Following the representation I made at the Essex Open Floor Hearing ahead of Deadline 1, and my subsequent follow up at Hearing 2, I have summarised my thoughts as to progress made on the issues I'd raised, but first wish to draw the Planning Inspectorate's attention to a new finding.

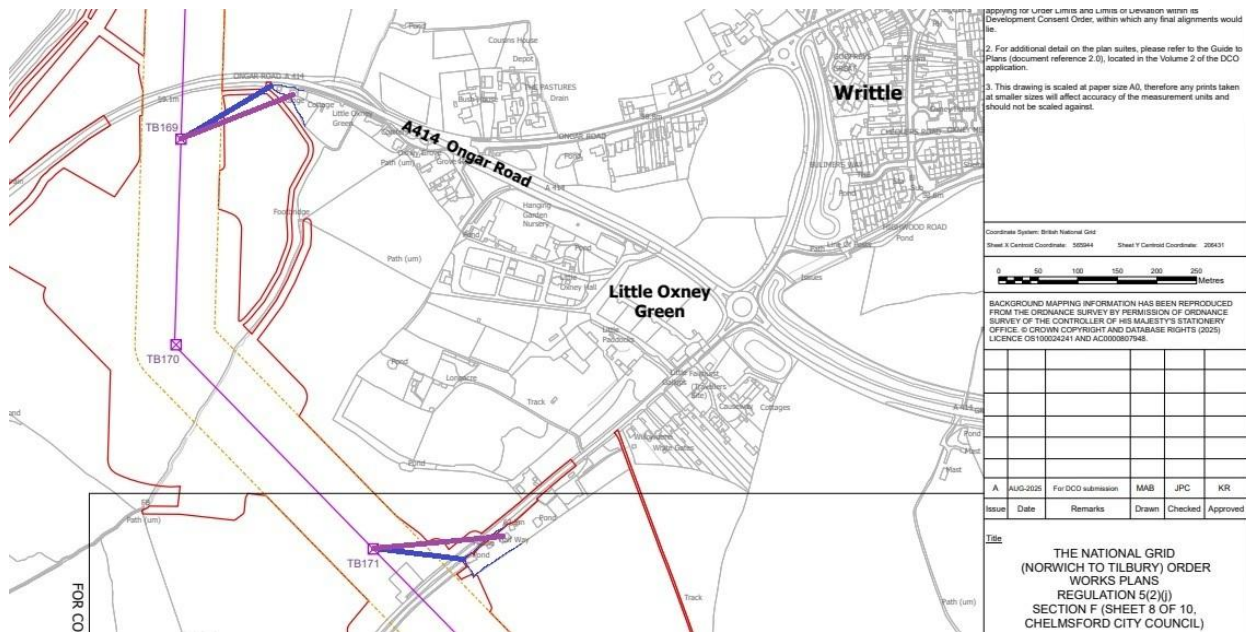
It is my opinion that the distances quoted in the RVAA document are to the property centre, and not the property curtilage. Several examples of this including my own property are as follows:

at the top of the screenshot and Halfway House at the bottom.

is listed in the RVAA document as being 152m from pylon TB169, and Halfway House 168m from TB171. However, using the property curtilage, I believe this to be ~120m for and 115m for Halfway House. If the route were to move by the allowed 50m, this has a significant impact to these properties.

As a consequence, I am of the opinion that the RVAA assessment for these properties is not valid, it changes the magnitude of effect, something which I already disagreed with as being dismissive and with far too much use of the word 'likely' in the write up. There should be definitive wording when so much is at stake for homeowners.
